03.1-04

TECHNICAL BULLETIN

Poor Idle Quality –
Normally Aspirated AJ16 Engine –
Valve Timing Modification

MODEL 1995 MY
4.0L NA
VIN
See engine no. below

ILLUSTRATION 1

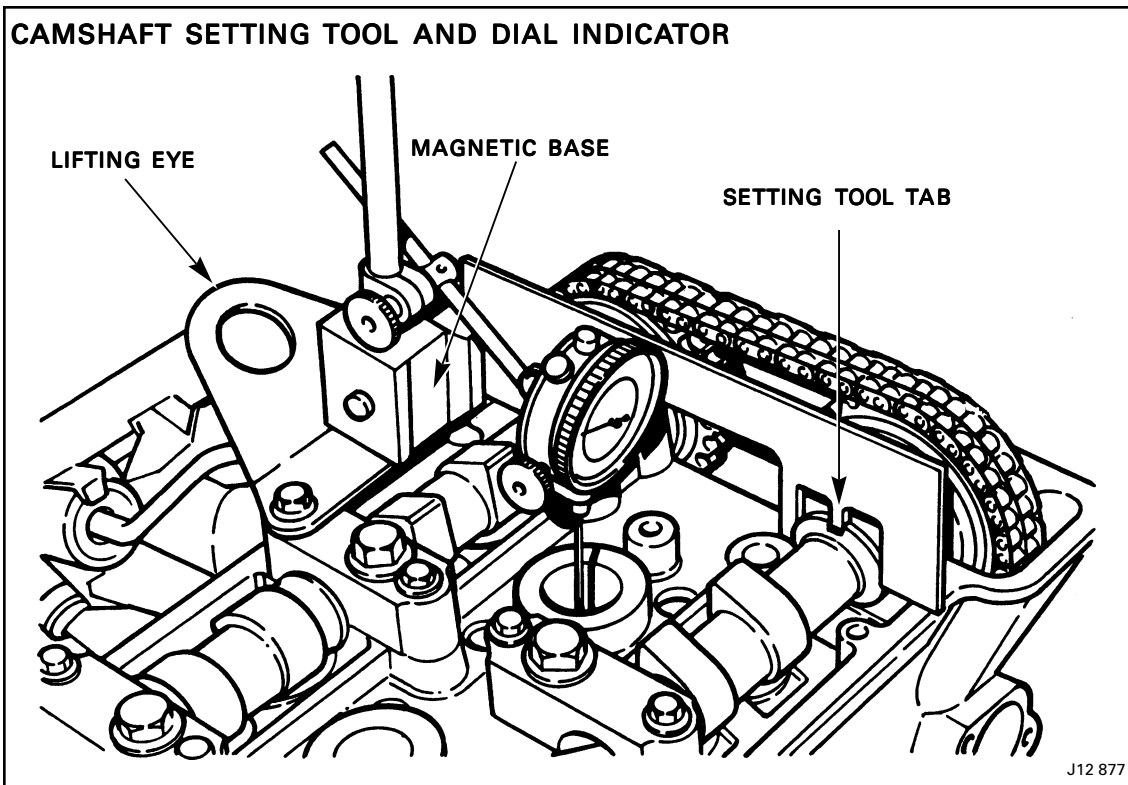
5. Turn the crankshaft until the No. 1 cylinder is at Top Dead Center (TDC) on the compression stroke, i.e. with the cam lobes on the No. 1 cylinder pointing upwards as in Illustration 1. This position can be checked by temporarily inserting the camshaft setting tool 18G-1433/A into the slot on each camshaft.

7. On all engines, attach an engine lifting eye to the intake camshaft cap as shown in Illustration 1.
8. Position the magnetic base of a dial indicator gauge on the lifting eye.
9. Install the dial indicator gauge with an extension pointing downward, into the spark plug bore, contacting the top of the piston.
10. Bend back the locking tabs that lock the bolts holding the camshaft sprocket vernier couplings to the camshafts. Loosen the bolts slightly, but do not remove them.
11. Remove the camshaft setting tool. Rotate the crankshaft back and forth slightly across the TDC position to determine the true TDC point for the no. 1 piston and then zero the gauge.

ILLUSTRATION 2

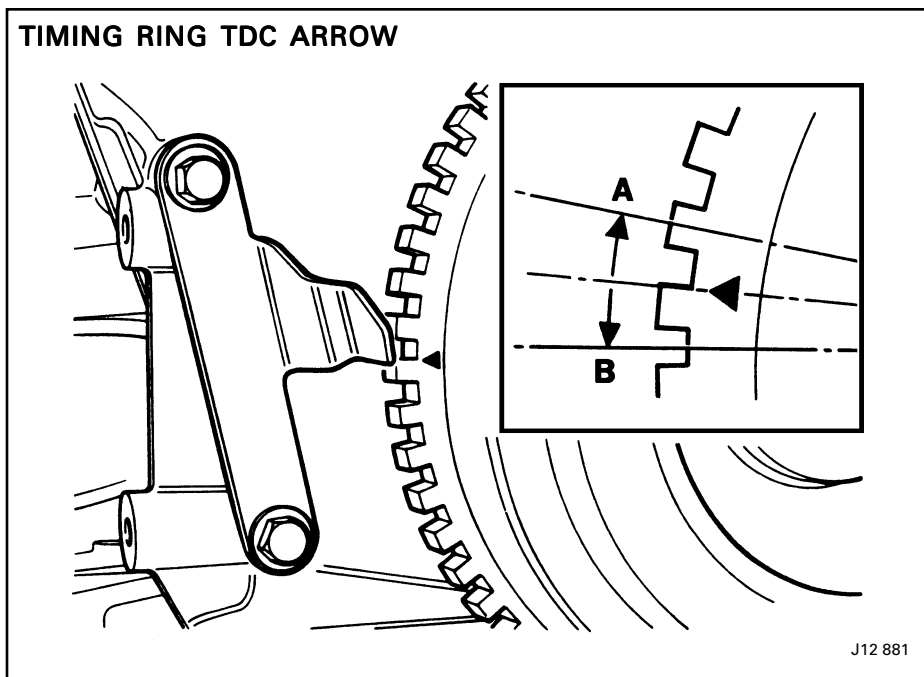
12. Check that the pointer on the front timing cover is in line with the arrowed (TDC) tooth edge on the timing ring, Illustration 2. Realign the pointer if necessary.
13. The crankshaft positions for resetting the camshafts are one and a half teeth on either side of the arrowed (TDC) tooth edge on the timing ring as shown in Illustration 2.
14. Rotate the crankshaft two revolutions in a clockwise direction (viewed from the front of the engine) until the pointer is one and a half teeth before the arrowed (TDC) tooth edge on the timing ring, position A, Illustration 2.

19. Install the locking tabs and the coupling bolts. Lightly tighten the bolts.
20. Remove the setting tool and turn the crankshaft in a clockwise direction (viewed from the front of the engine) until the pointer is one and a half teeth after the arrowed (TDC) tooth edge on the timing ring, position B, Illustration 2.

27. Check both the settings of one and a half teeth before and after the arrowed (TDC) tooth edge on the timing ring, Illustration 2. The tab of the setting gauge should fit in the slot of the camshaft being checked.

ILLUSTRATION 3

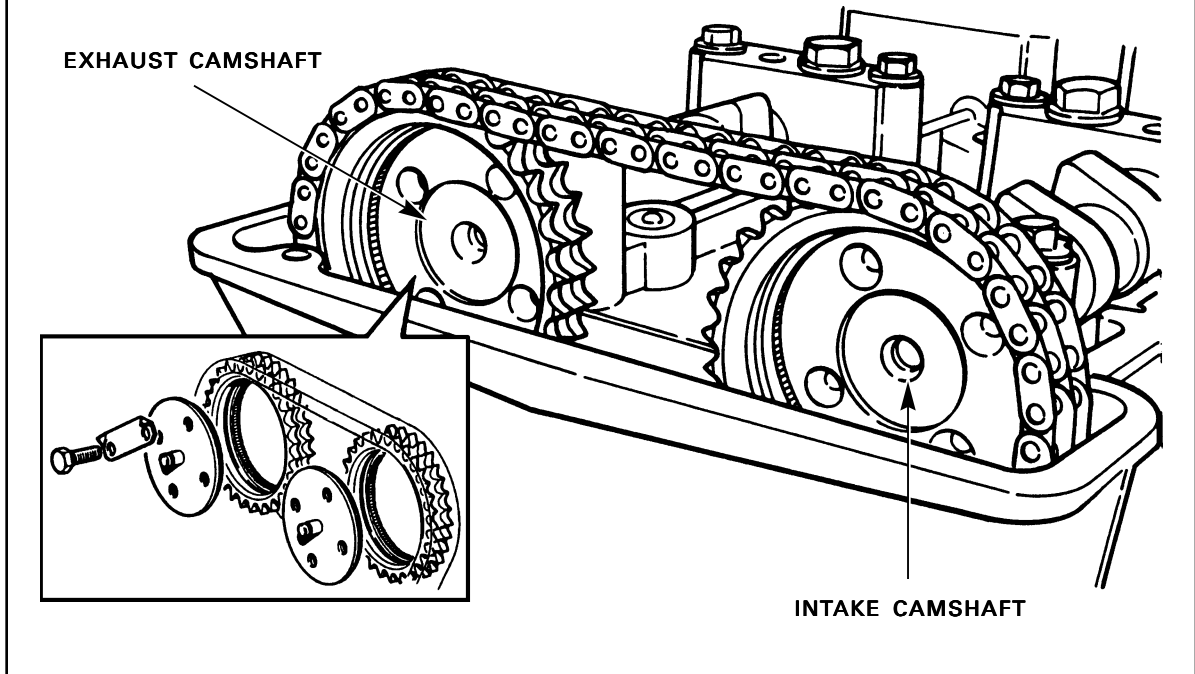
15. Remove the retaining bolts and the camshaft sprocket vernier coupling, Illustration 3, from the exhaust camshaft, but do not detach the sprocket from the camshaft flange. The camshaft is free to rotate inside the sprocket with the coupling removed.
16. Position the camshaft setting tool 18G-1433/A across the camshafts with the positioning tab on the exhaust camshaft, Illustration 1.
17. Turn the exhaust camshaft until the tab on the setting tool engages the slot in the camshaft.
18. With the camshaft in this position, reinstall the sprocket vernier coupling to the exhaust camshaft. This step will require several attempts to find the exact alignment of the vernier splines and the bolt holes.

21. Remove the retaining bolts and the camshaft sprocket vernier coupling, Illustration 3, from the intake camshaft, but do not detach the sprocket from the camshaft flange. The camshaft is free to rotate inside the sprocket with the coupling removed.
22. Position the camshaft setting tool 18G-1433/A across the camshafts with the positioning tab on the intake camshaft.
23. Turn the intake camshaft until the tab on the setting tool engages the slot in the camshaft.
24. With the camshaft in this position, reinstall the sprocket vernier coupling to the intake camshaft. This step will require several attempts to find the exact alignment of the vernier splines and the bolt holes.
25. Install the locking tabs and the coupling bolts. Lightly tighten the bolts.

26. Remove the setting tool and final tighten the camshaft sprocket vernier coupling bolts to 16.2 - 20.6 lb ft (22 - 28 Nm). Bend the lock tabs against the bolt heads.

ILLUSTRATION 4

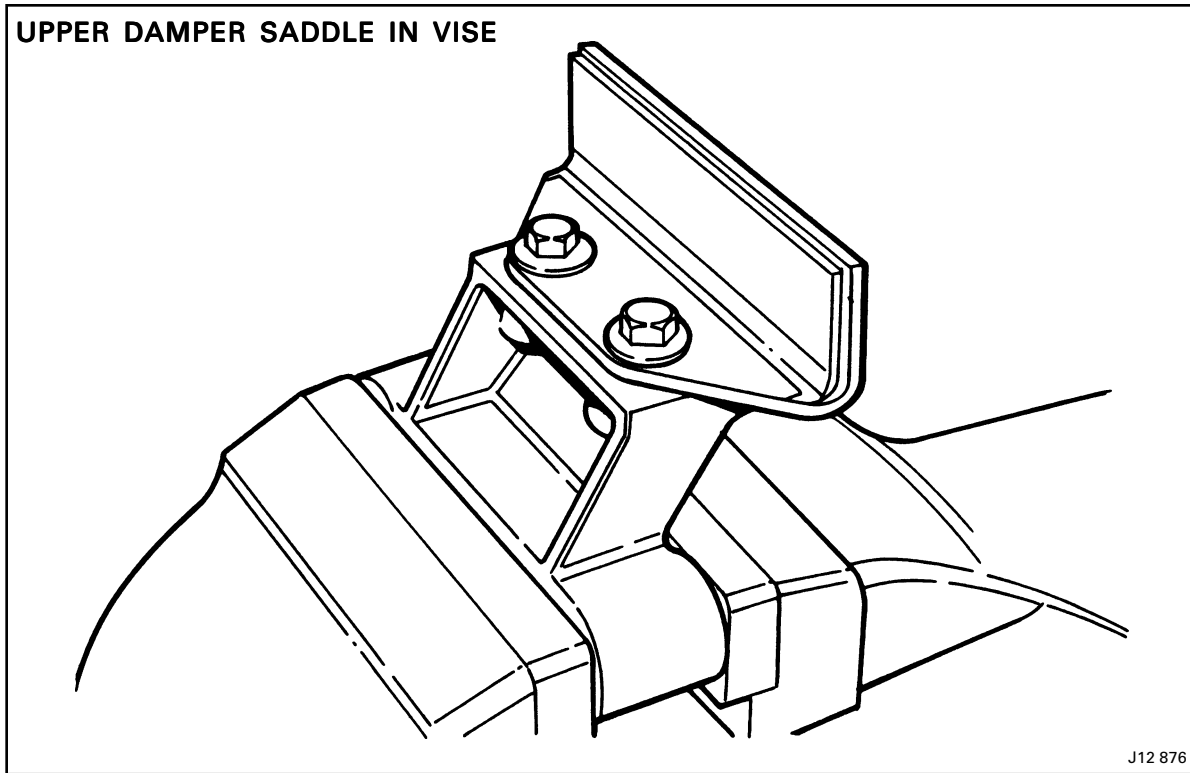
28. Remove the setting tool, the dial indicator gauge, and the lifting eye. Torque camshaft bearing cap bolt to 12.5 - 16.9 lb ft (17 - 23 Nm).
29. On engines with numbers below 9L103934 (XJS Range) or 9J103935 (Sedan Range) only, remove the damper saddle retaining bolts, Illustration 4. Thoroughly degrease the bolts and the saddle. Apply Loctite 545, part number 54531 to the bolt threads and torque to 15.8 - 21 lb ft (21.5 - 28.5 Nm). Install the damper saddle using new cylinder head bolts and torque to 43.5 - 44.9 lb ft (59 - 61 Nm) plus 90 degrees as described in section 2.1 of the AJ16 Engine Service Manual.

NOTE: Engines starting with 9L103934 (XJS Range) or 9J103935 (Sedan Range) do not require modification since the damper saddles are equipped with self locking bolts.

ILLUSTRATION 5

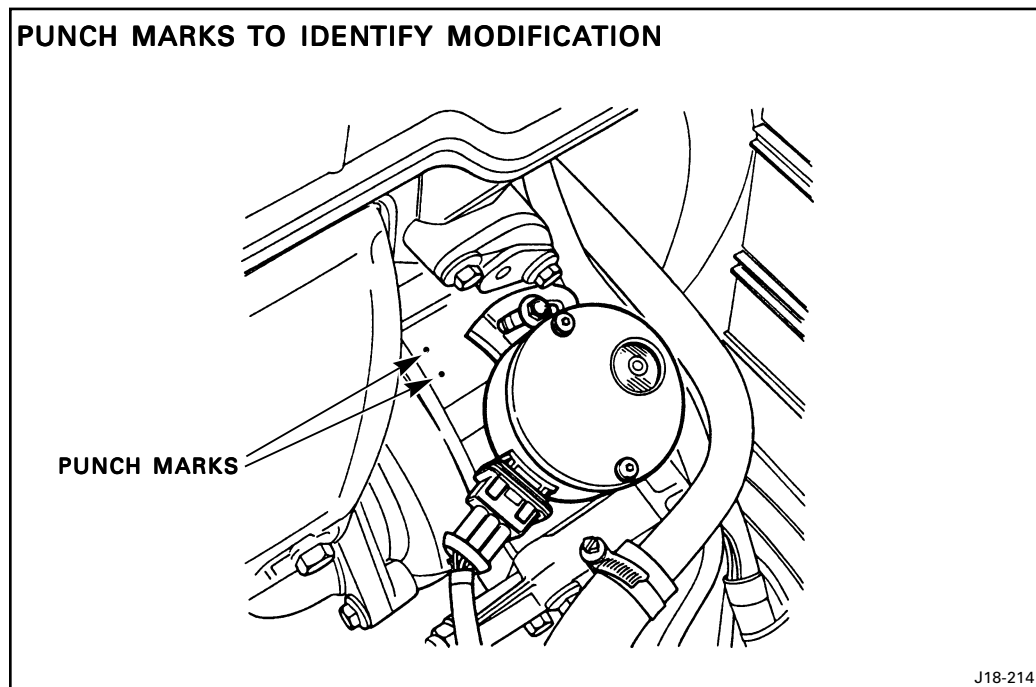
In case of a customer complaint of poor idle quality on a vehicle equipped with the 110 camshafts only, first check for punch marks on the timing cover near the camshaft position sensor, Illustration 5, to determine if the timing modification has already been performed. If not, reset the camshaft timing and spark plug gap as described below.

33. Place two punch marks approximately 1/4 inch apart on the timing cover parallel to the lip, Illustration 5, to indicate that the modification was done.
34. Connect the battery negative cable and reset the clock.
